FIRE SAFETY INSPECTION REPORT

B2B EXCELLENCE LTD
MIRZAPUR PURBAPARA, 8 NO MIRZAPUR MOWZA,
MIRZAPUR,

ACC  **RD**
on Fire and Building Safety in Bangladesh

June 26, 2014

F-3 Egress

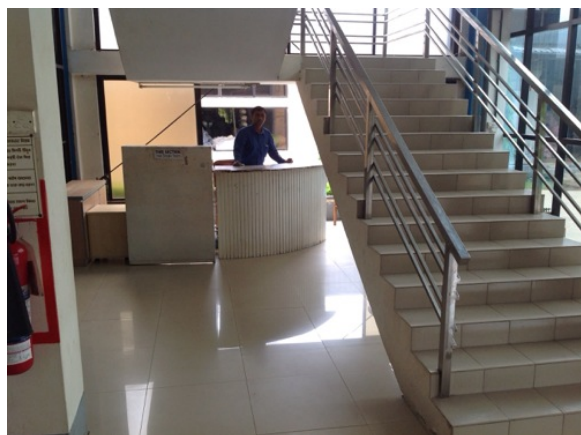
Egress doors and gates with locking features are provided at building exit discharge.

Remove locking features from all egress doors / gates.

Immediate

If locks are required for security reasons, utilize special door locking features complying with NFPA 101.

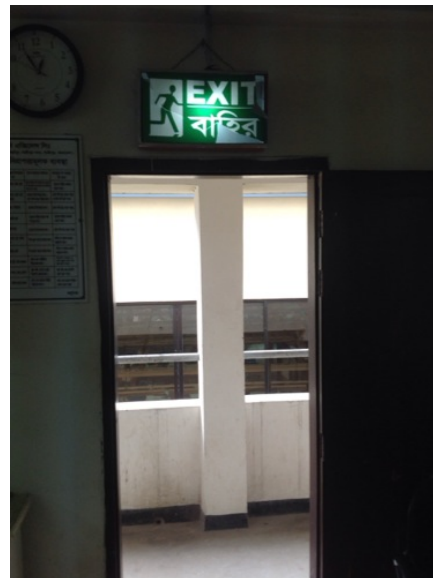
| F-3 | Fire Rated Construction | The exit discharge path serving north exit is less than 10 ft wide and is not separated from the building interior. | Seal all penetrations and openings to the interior of the building along the discharge path, up to a height of 10 ft., to provide a minimum 1-hr fire separation. Alternatively, provide a second remote discharge path to the public way (only include this if feasible). | Within 6 months |
